UNITED STATES PATENT AND TRADEMARK OFFICE

APPLICATION NO.	FILING DATE	FIRST NAMED INVENTOR	ATTORNEY DOCKET NO.	CONFIRMATION NO.
09/974,780	10/09/2001	Max Schaldach	7040-46	6883

Office Action Summary	Application No. 09/974,780	Applicant(s) SCHALDACH ET AL.	
	Examiner Jessica R Baxter	Art Unit 3731

DETAILED ACTION

FIG.1

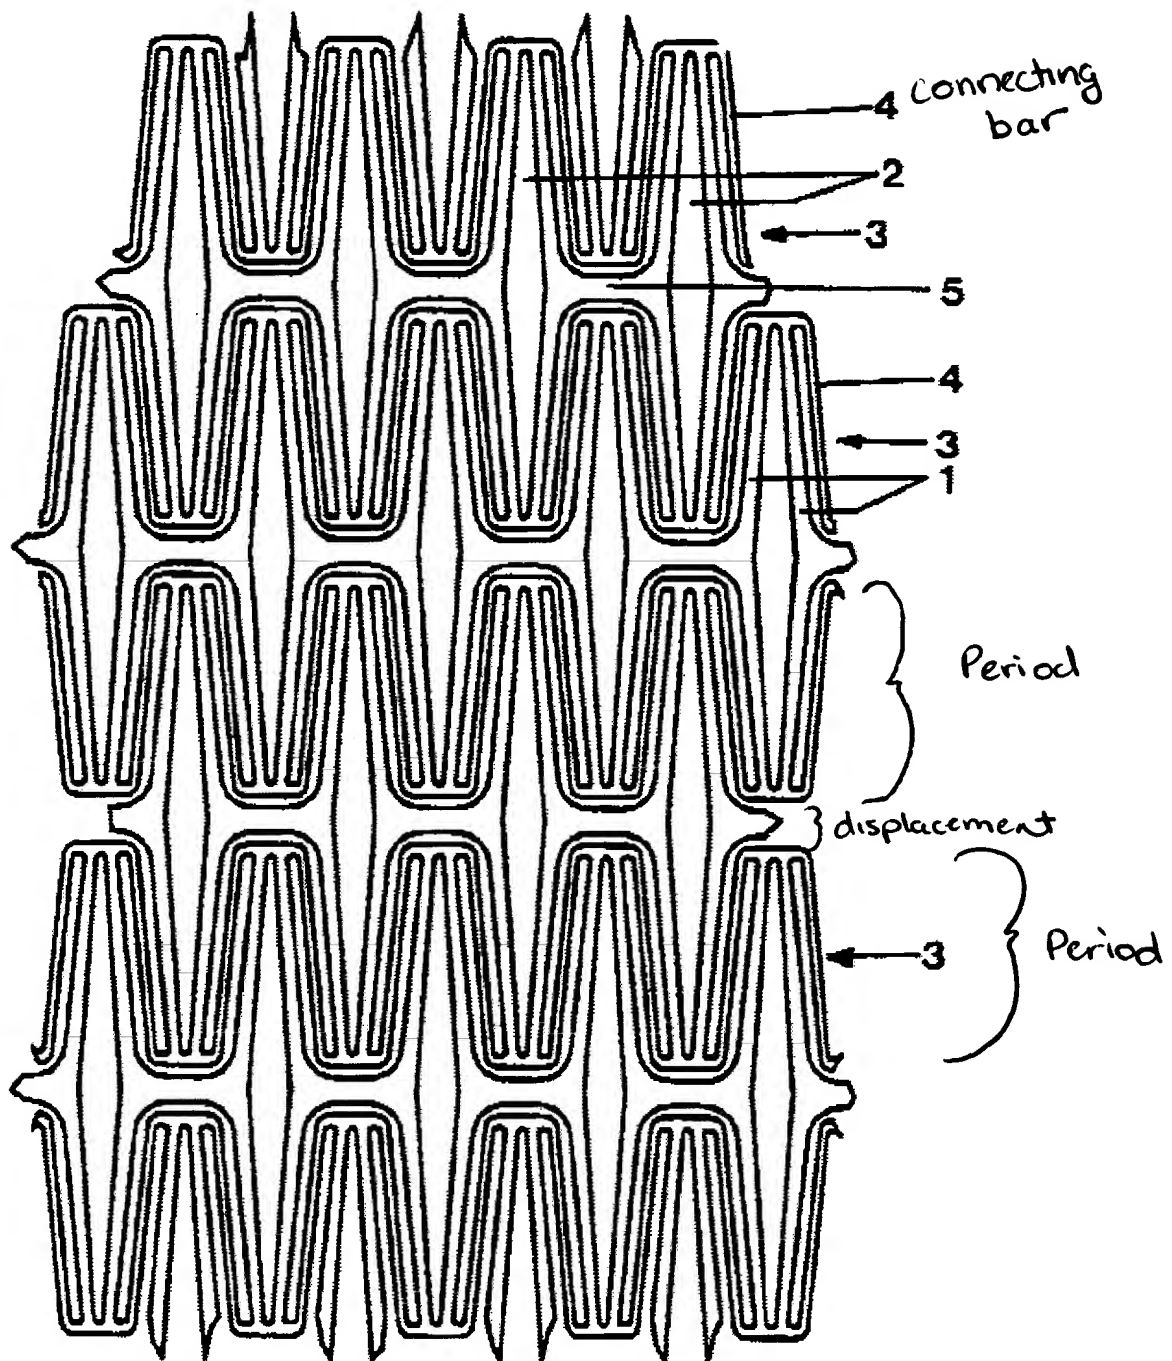
Regarding claims 1 and 59, Haindl discloses a stent, for expansion from a first condition into an expanded second condition in which it holds a vessel in an expanded state (Column 1 lines 58-60), said stent comprising: a tubular body, a peripheral surface of which is formed by a plurality of support portions that extend in a longitudinal direction of the stent, the support portions comprising: a plurality of bar elements; and a plurality of connecting bars, extending rectilinearly in the longitudinal direction of the stent when in the first condition, that connect the bar elements; wherein the support portions form a plurality of support portion groups with at least a first support portion and a second support portion in adjacent relationship thereto in a peripheral direction of the stent, the bar elements of which extend in a meander configuration in the longitudinal direction of the stent, and wherein a first engagement point of the connecting bars engages the first support portion and a second engagement point of the connecting bars engages the second support portion, such that the first and second engagement points are spaced apart from each other in the longitudinal direction of the stent and the connecting bars are configured and arranged so the spacing in the longitudinal direction between the first and second engagement points decreases upon expansion of the stent (see attached FIGS 1 and 2 for details).

Regarding claims 34, 35, 36, 37, 38, 39 and 40, Haindl discloses that the bar elements of the first and second support portions are of substantially the same periodic configuration and a length of the connecting bars is such that the adjacent bar elements in the first condition of the stent are displaced relative to each other by up to a quarter period in the longitudinal direction of the stent (see FIG. 1).

FIG.2

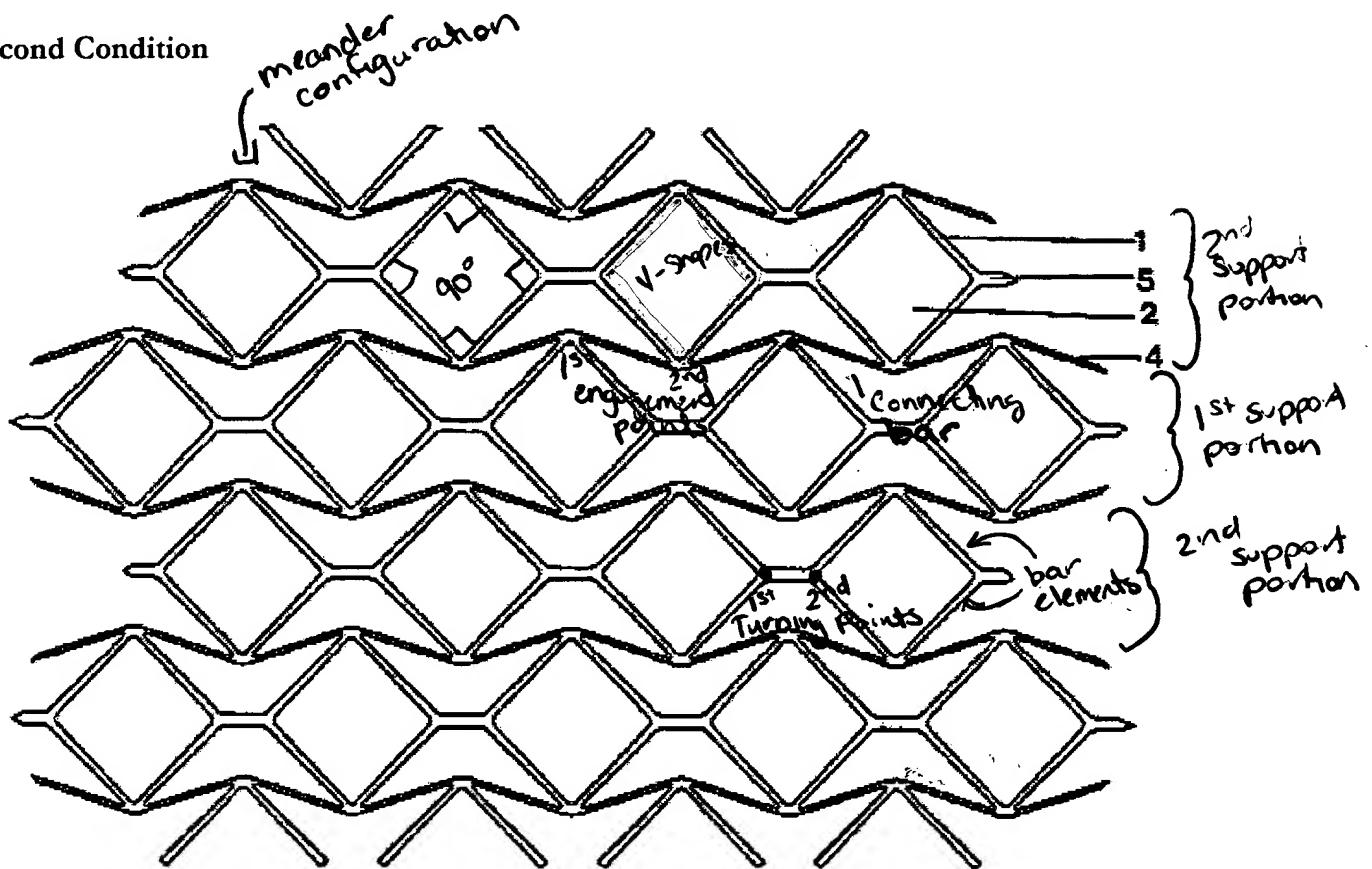
points decreases upon expansion of the stent in the same manner. Compare attached FIGS. 1 and 2 connecting bars.

Regarding claims 3 and 5 Haindl discloses that at least the first engagement points of the connecting bars are located near a turning point of the bar element to which the connecting point is engaged (See FIG. 2).

Regarding claims 4 and 6, Haindl discloses that the second engagement points of the connecting bars are located near a turning point of the bar element to which the connecting point is engaged (see FIG. 2).

Regarding claims 7, 8, 9 and 10, Haindl discloses that the connecting bars are of a substantially straight configuration (See FIG. 2).

Regarding claims 11, 12, 13, 14 and 15, Haindl discloses that a connecting line between the first and second engagement points extends *substantially* in the longitudinal direction of the stent (see FIG. 2).

Regarding claims 16, 17, 18, 19, 20 and 21, Haindl discloses that at least one support portion is formed by bar elements extending in a meander configuration in the longitudinal direction of the stent, wherein the bar elements comprise two bar element portions that are adjacent in the longitudinal direction of the stent and which extend between a turning point to form the limbs of a V-shape (see FIG. 2).

Regarding claims 22, 24, 26, 28, 30 and 32, Haindl discloses that the bar element portions include an angle of between 80° and 100 °(see FIG.2).

Regarding claims 23, 25, 27, 29, 31 and 3, Haindl discloses that the bar element portions include an angle of 90°(see FIG. 2).

Regarding claims 41, 42, 43, 44, 45, 46, 47, 48 and 49, Haindl discloses that the bar elements of the first and second support portions are of substantially the same period configuration and a length of the connecting bars is such that in the second condition of the stent the adjacent bar elements extend substantially in phase with each other with respect to the longitudinal direction of the stent (see FIG. 2).

Regarding claim 58, Haindl discloses that at least one support portion formed by a bar element, the direction of curvature of which changes in a central region between a pair of turning points (see FIG. 2).
